NOTICE OF DECISION

DECISION OF THE PLANNING COMMISSION

**CLASS 3 DESIGN REVIEW / CLASS 3 SITE PLAN REVIEW / CLASS 2
ADJUSTMENT / CLASS 1 ADJUSTMENT / CLASS 2 DRIVEWAY APPROACH
PERMIT CASE NO. DR-SPR-ADJ-DAP16-02**

APPLICATION SUMMARY: A request for a Design Review, Site Plan Review, Adjustments, Driveway Approach Permit with adjustments to street setbacks, side vehicle use area setbacks, and number of driveways from property to Red Leaf Drive S to allow a 127-unit multi-family use on the subject property.

A5.8

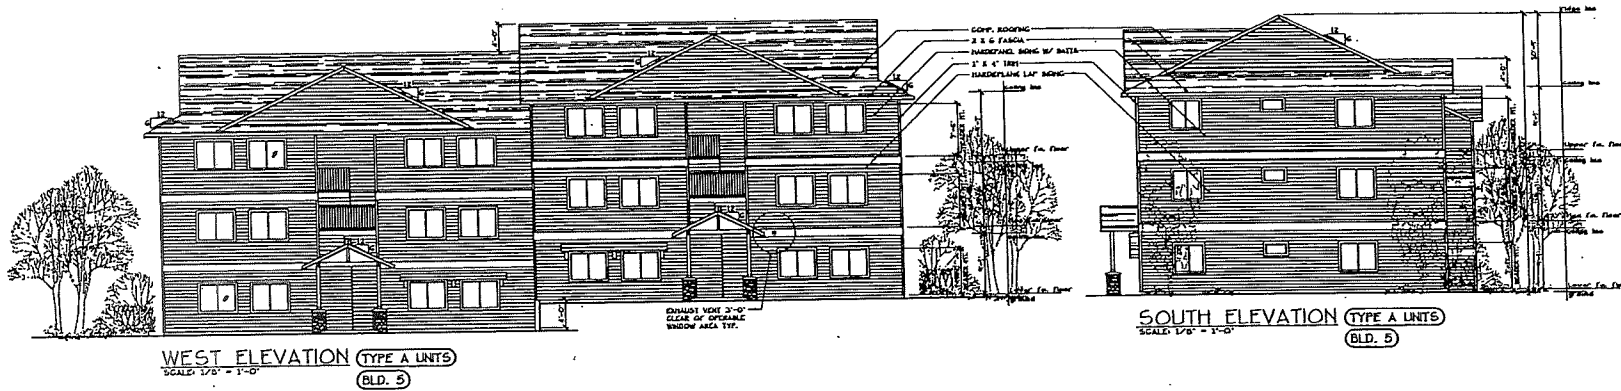
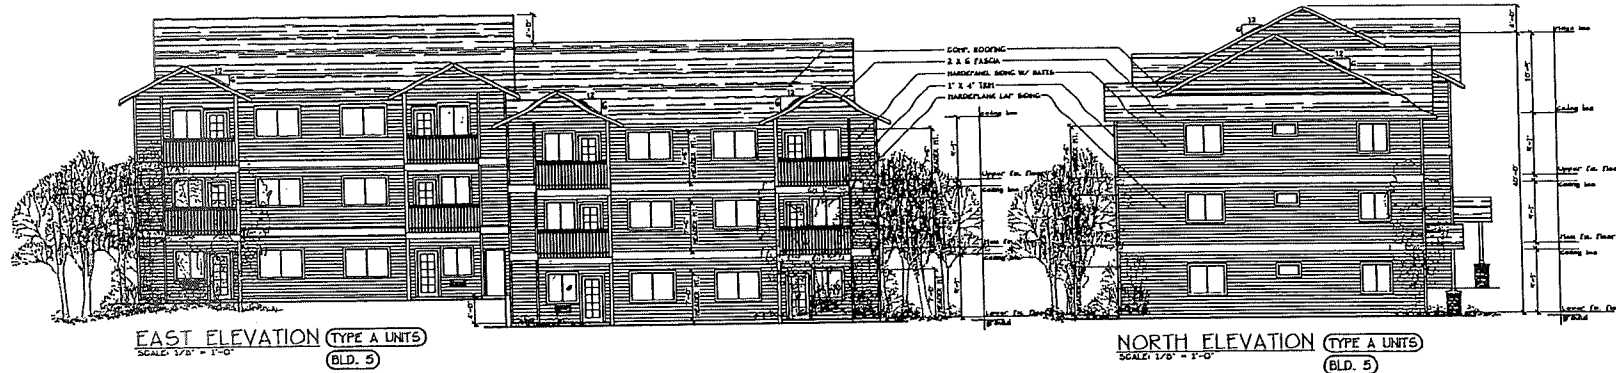
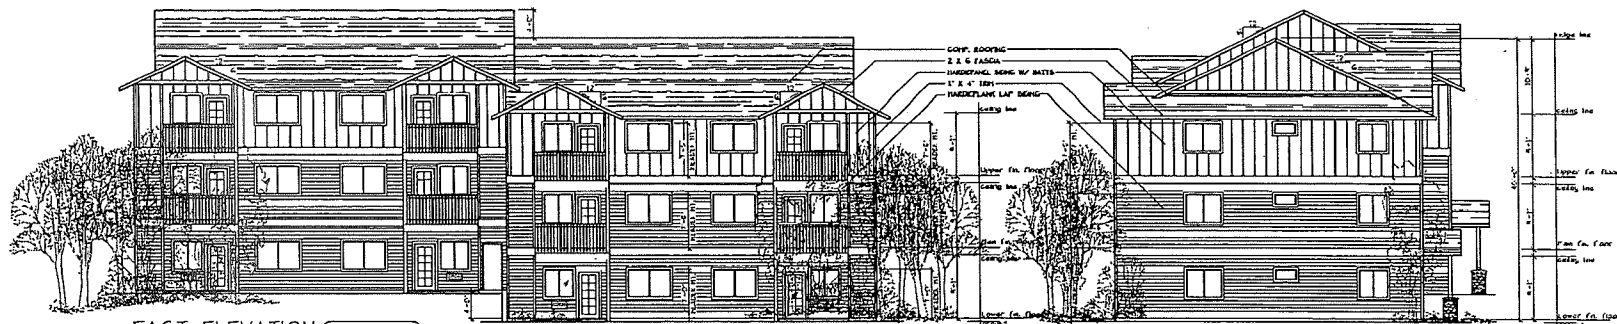
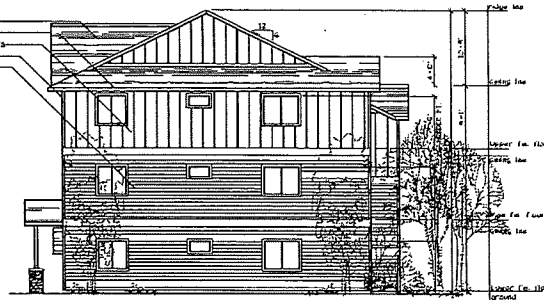
- Condition 8:** The proposed buildings shall be revised to provide additional contrast and distinction between the ground floor and upper floor facades by incorporating one or more of the following:
